**ORDINANCE NUMBER 2016-09**

**AN ORDINANCE OF THE TOWN OF PARADISE VALLEY,  
ARIZONA AMENDING THE PARADISE VALLEY ZONING  
ORDINANCE, Article XXII, HILLSIDE DEVELOPMENT  
REGULATIONS**

Section 1. Article XXII, Hillside Development Regulations, Section 2200- 2209 are hereby amended (with deletions shown as ~~strikethroughs~~ and additions shown in **bold type**):

**FIGURE 2-1 – HILLSIDE DEVELOPMENT AREA**

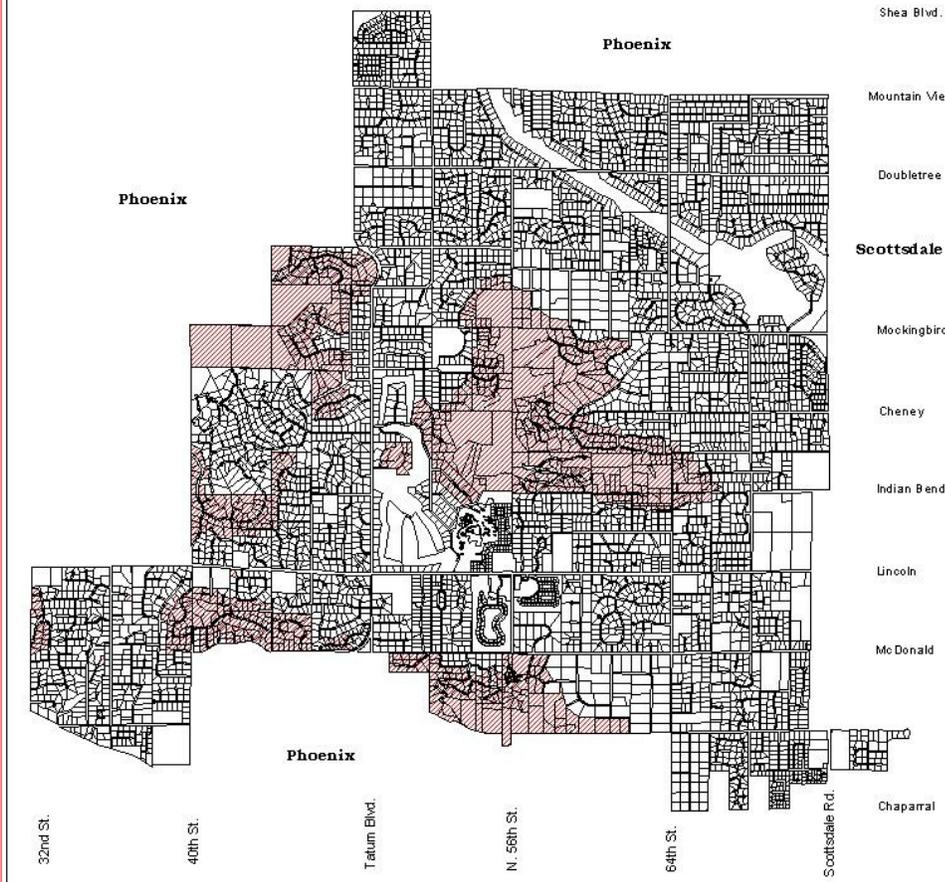
**Comment [GB1]:** Identify Process to Update Map with any properties removed from Hillside or added to Hillside

**FIGURE 3 – PRIMARY RIDGE LINE DESIGNATION**

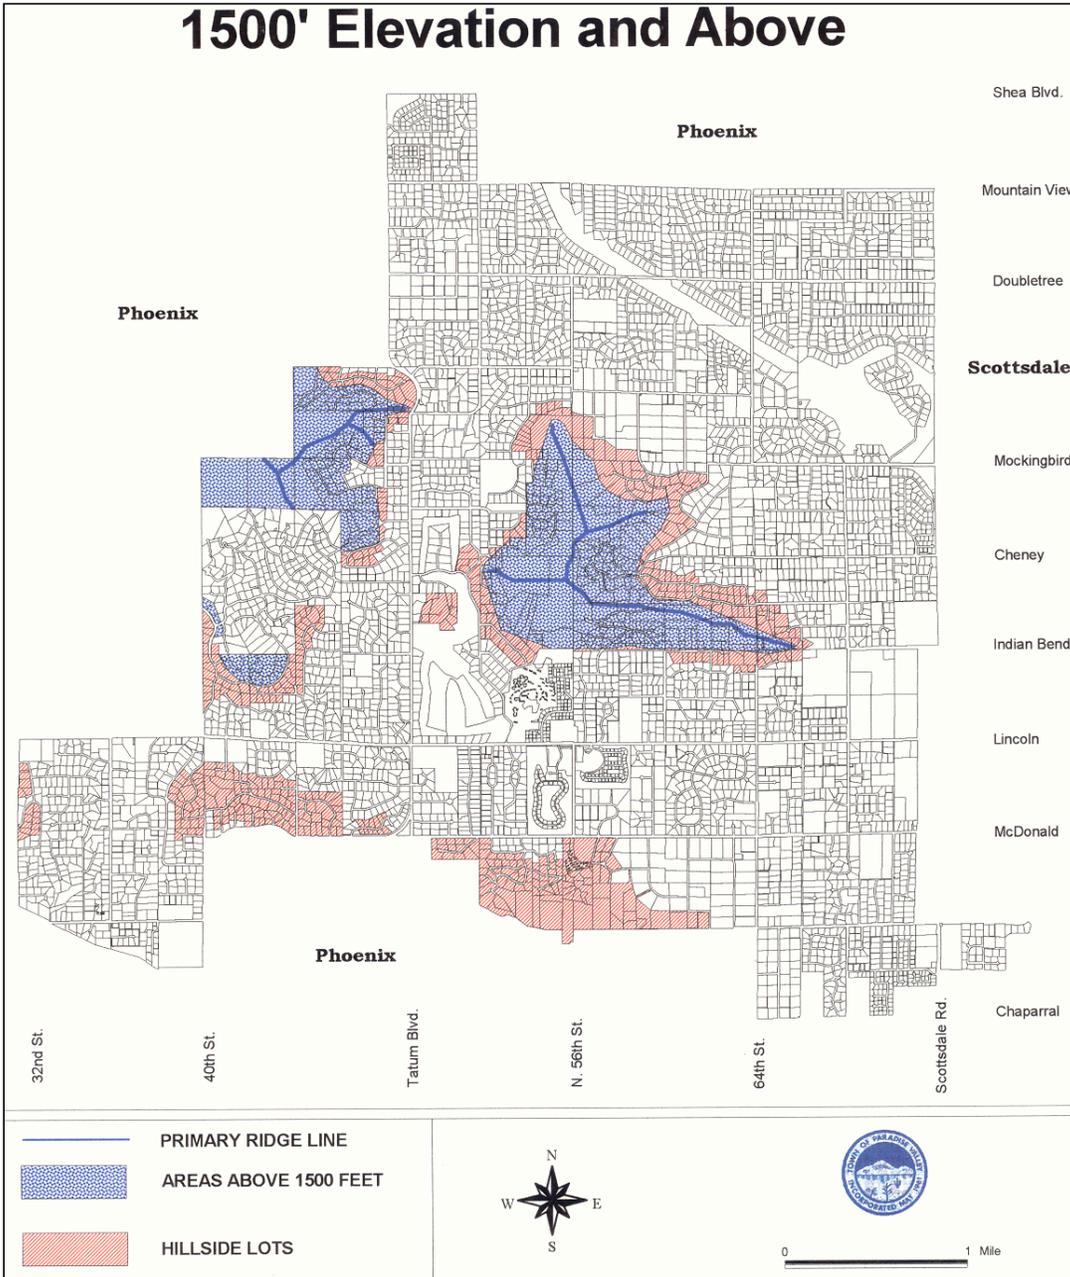
Comment [GB2]: Figure 3 Moved after Definition Section on Page 9

**FIGURE 5 – BUILDING HEIGHT IN HILLSIDE**

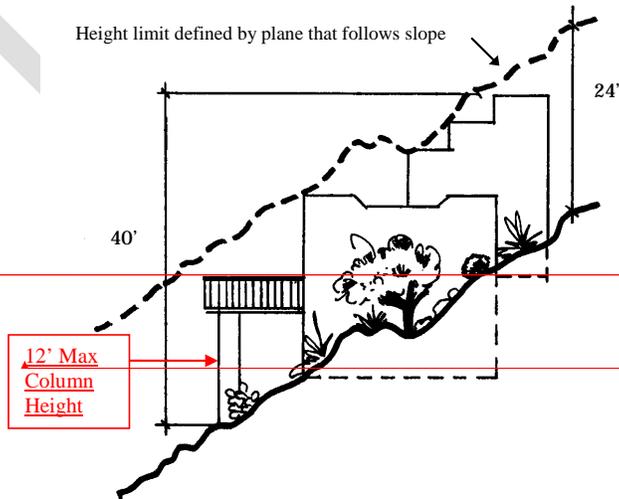
Comment [GB6]: Figure 5 to be updated to reflect these edits.

Comment [GB7]: Update Figure 5 to clarify measurement of 40' maximum height limit.

iii. 3. The maximum overall height of the building or structure, including chimneys and accessory buildings, shall not exceed forty (40) feet from the highest point of ~~the building to natural grade at the lowest point adjacent to the building structure or column~~ of a building or structure to the lowest point of Natural Grade at the lowest building or structure (excluding driveway retaining walls) --(see FIGURE 5).

FIGURE 7 - HEIGHT FOR A CANTILEVERED ELEMENT

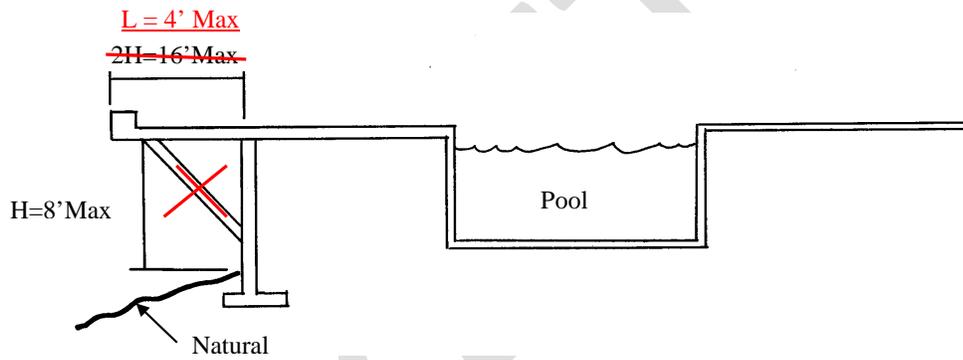
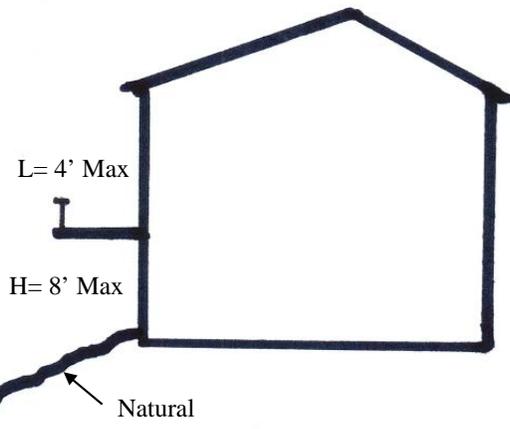
Comment [GB8]: New figures to be added to the code to illustrate these scenarios.

Comment [GB9]: Remove support from illustration and change horizontal to 4' max on Figure 7.

**FIGURE 8 – TERRACED VERTICAL RETAINING WALLS**

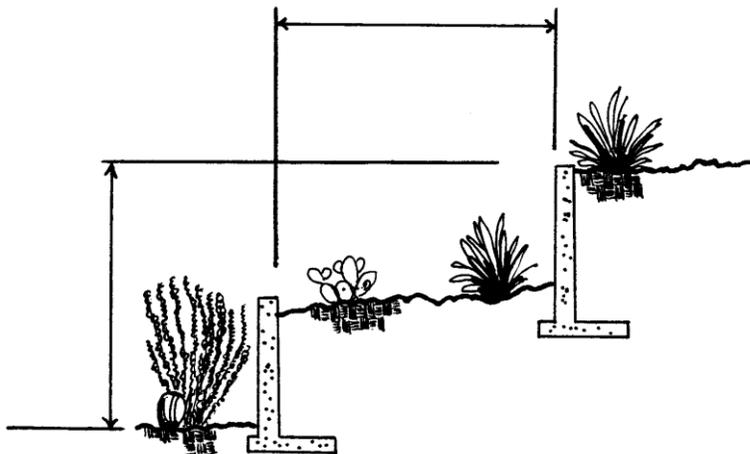
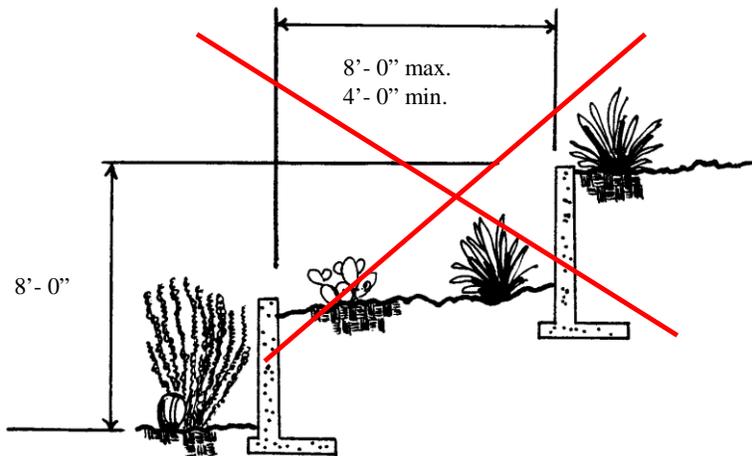
Comment [GB12]: Relocate Figure 8 below the text of 2207.VI.1.e.
